# **KCE-1 Critical Heat Flux Correlation for PLUS7 Thermal Design**

APR1400-F-C-TR-12002-NP-A

SUBJECT: APR1400 FINAL SAFETY EVALUATION FOR TOPICAL REPORT  
APR1400-F-C-TR-12002-P, REVISION 0, "KCE-1 CRITICAL HEAT FLUX  
CORRELATION FOR PLUS7 THERMAL DESIGN"

Figure 2-2 Instrumentation Arrangement

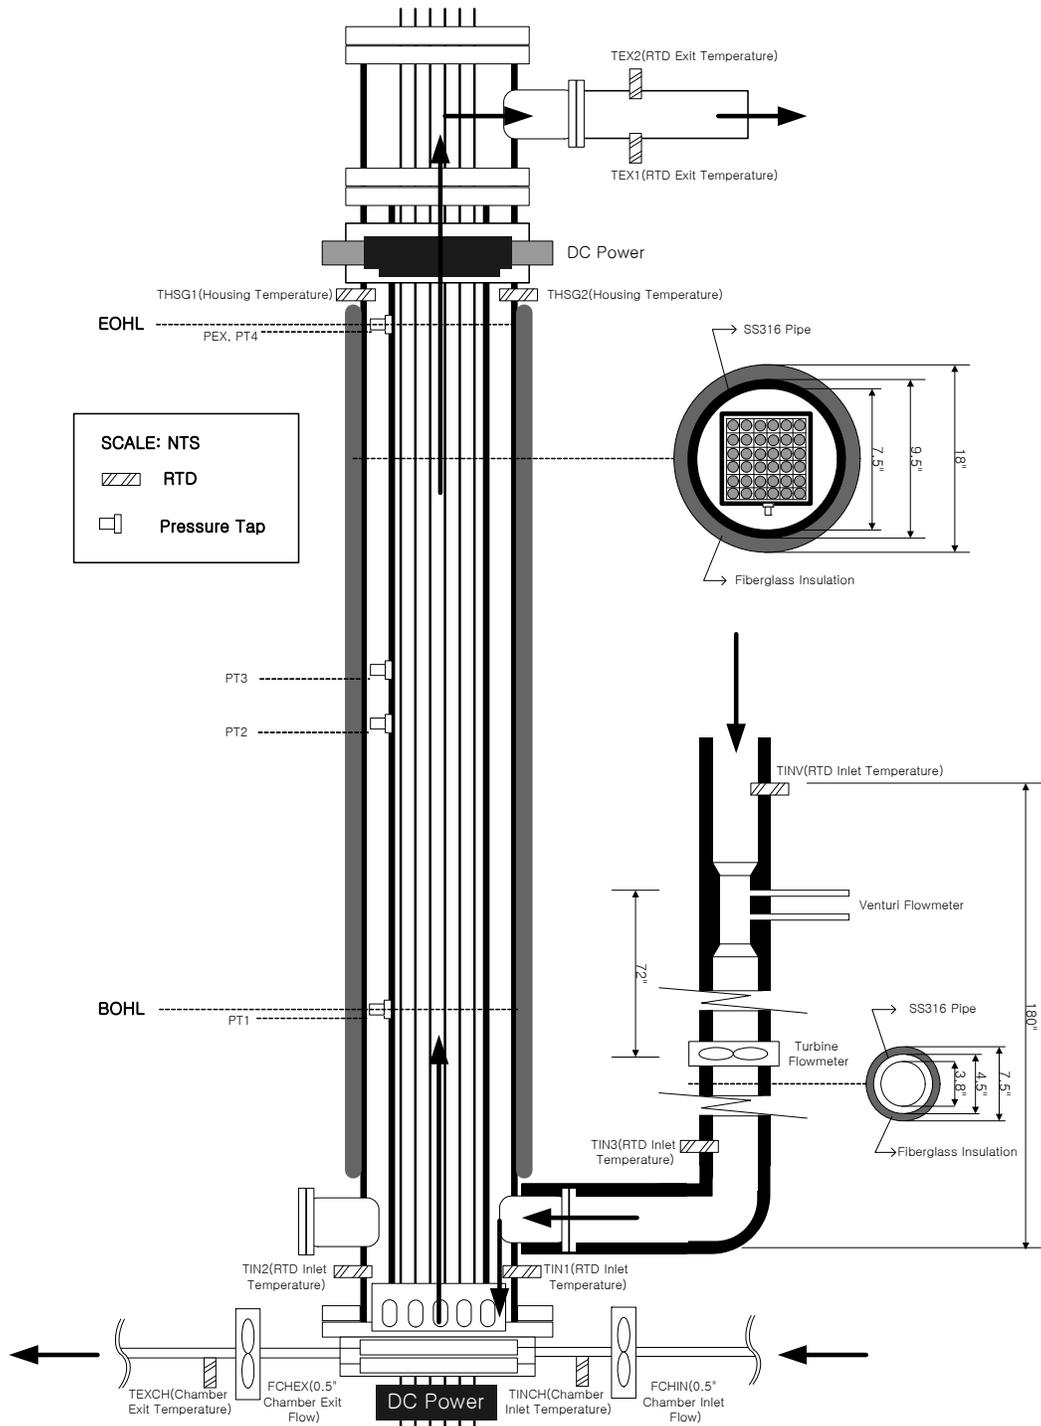
The TR reports that the test section flow was measured by two (2) Venturi flow meters and a turbine meter prior to the entrance to the test section flow housing. However, Figure 2-2 shows only one Venturi flow meter, and not the two. Describe the logic behind using this flow rate measurement arrangement. Was there any parallel arrangement made to manually measure the pressure drops across the Venturi flow meter as well as the test section using manometers, as has been the methodology used in other CHF test programs?

*Figure 2-2 of the topical report is not a detailed drawing but an overall schematic sketch of instrumentation arrangement. Thus, some components are not depicted in the sketch.*

Figure 2-9 Axial Geometrical Configuration of Test Section

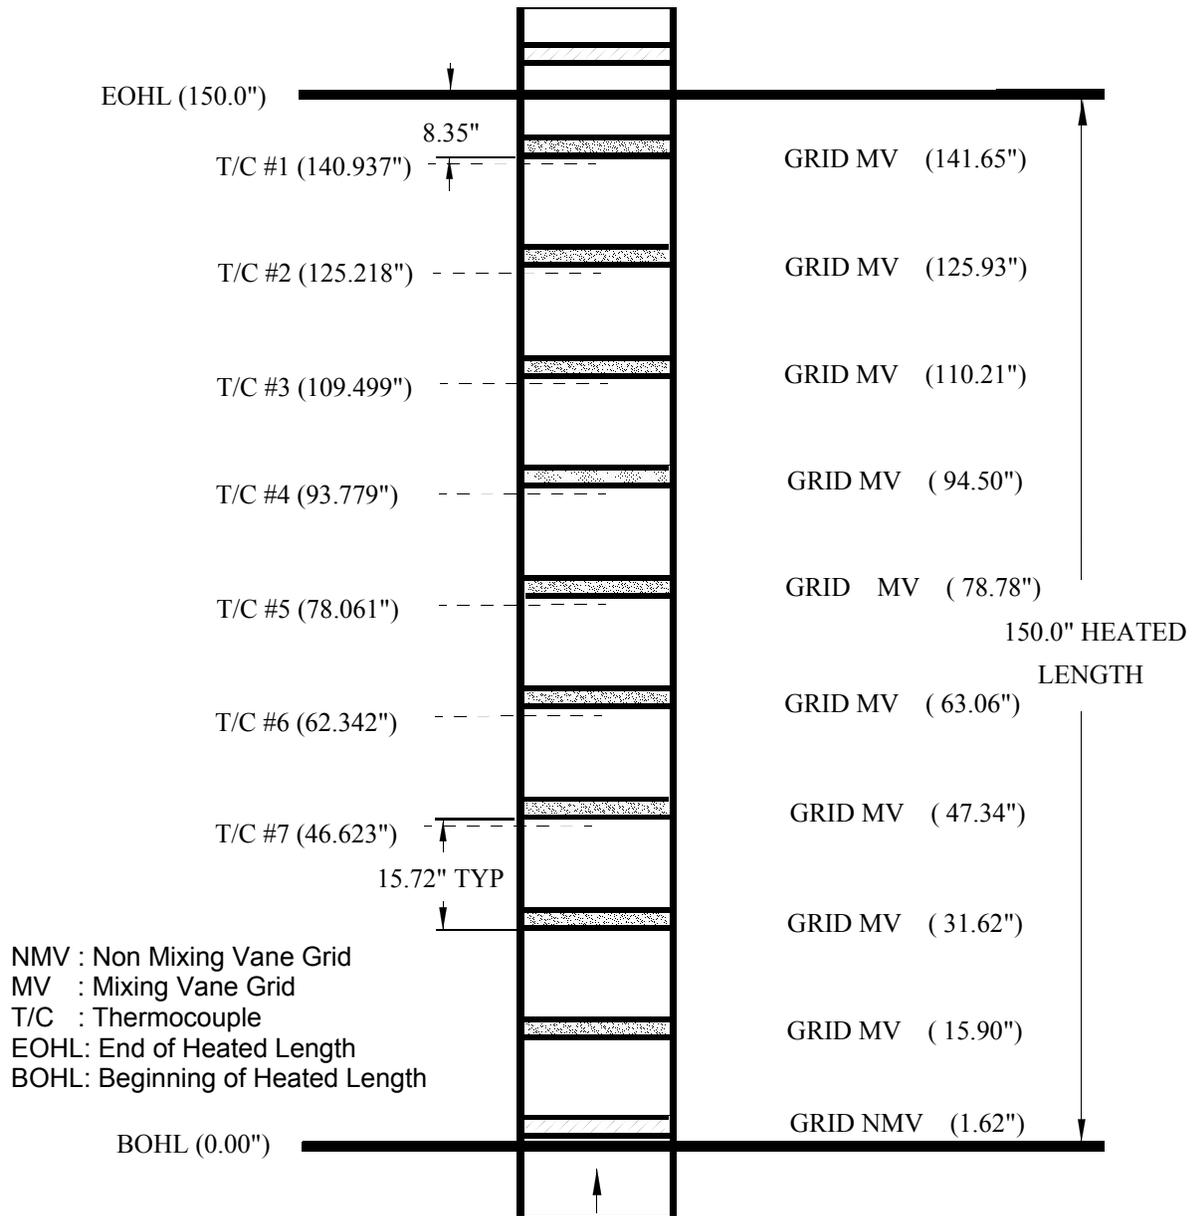
Figure 2-9 depicts seven thermocouples installed axially to measure the wall temperature of the heater rods. However, the thermocouple grid is asymmetrical between the BOHL (Beginning of Heated Length) and EOHL (End of Heated Length). Justify the temperature measurements made by using the asymmetrical thermocouples grid to be conservative with reference to the overall data reduction to compute CHF.

*According to actual test data, the CHF elevations are limited to [ ]<sup>TS</sup> as summarized in Figure 3-1 below, and Table A-1 of the topical report. No CHF is indicated at other locations including BOHL and EOHL.*

Figure 4-1 System Pressure versus Average Heat Flux of Test Section

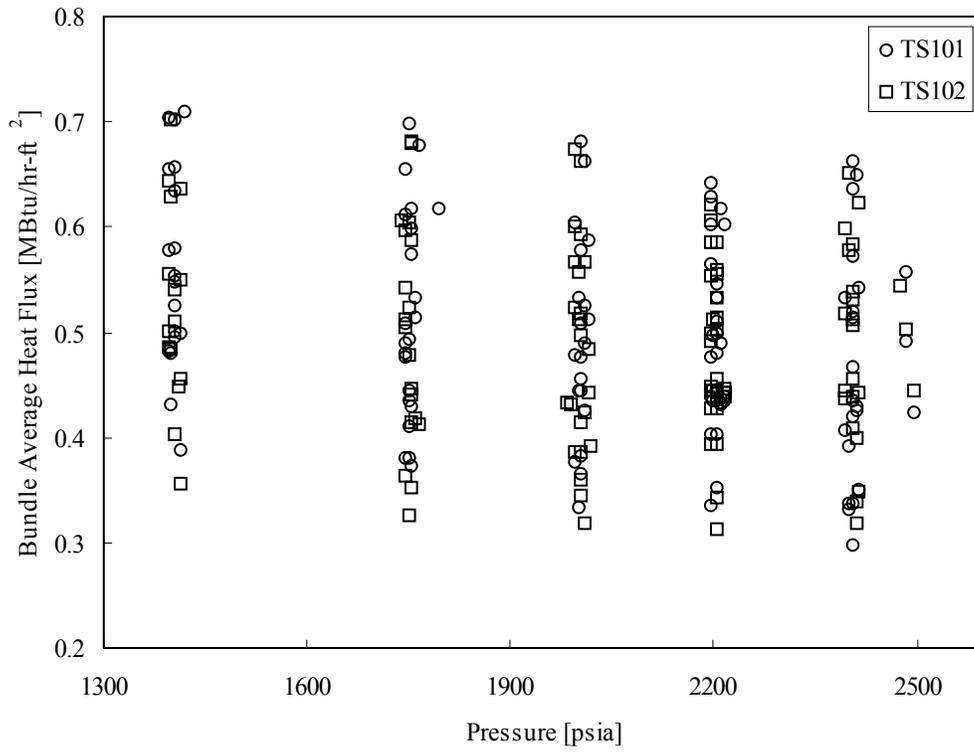
As identified in Figure 4-1, "System Pressure versus Average Heat Flux of Test Section," of the TR, [

] in Figure 4-3, "Inlet Mass Flux versus Average Heat Flux of Test Section," were also excluded by the applicant for the same reason. The staff considers that this has effectively reduced the application domain of the KCE-1 correlation to a maximum 2,415 psia (16.65 MPa) pressure and 3.15 Mlb<sub>m</sub>/hr-ft<sup>2</sup> (4,272 kg/s-m<sup>2</sup>) inlet mass flux. In RAI 3-7443, Question 18, the staff asked to inquire about the technical bases for selecting the applicable ranges, and whether the applicant envisions the actual PLUS7 design exceeding these ranges in any circumstances. In its response to RAI 3-7443, Question 18 (Ref. 11), the applicant provided the design analysis range of the APR1400 in Table 18-1 along with the applicable range of the KCE-1 correlation. The applicant stated that all APR1400 design/safety analyses are performed within the applicable range of the KCE-1 correlation at the MDNBR location. Among the variables included in Table 18-1, "Range of AOO Design Analysis for APR1400," the APR1400 design analysis range is within the applicable range of the KCE-1 correlation for pressure and local quality. For inlet mass flux, the upper limit of the KCE-1 correlation range is slightly lower than the APR1400 design analysis range. However, the local mass flux at the location of MDNBR in actual core analyses is still within the applicable range of the KCE-1 correlation. The higher pressure drop because of higher power and higher quality of the hot subchannel, where calculated DNBR is the minimum, reduces the flow by redistributing it from the hot subchannel to surrounding subchannels. Even though the excluded data were [
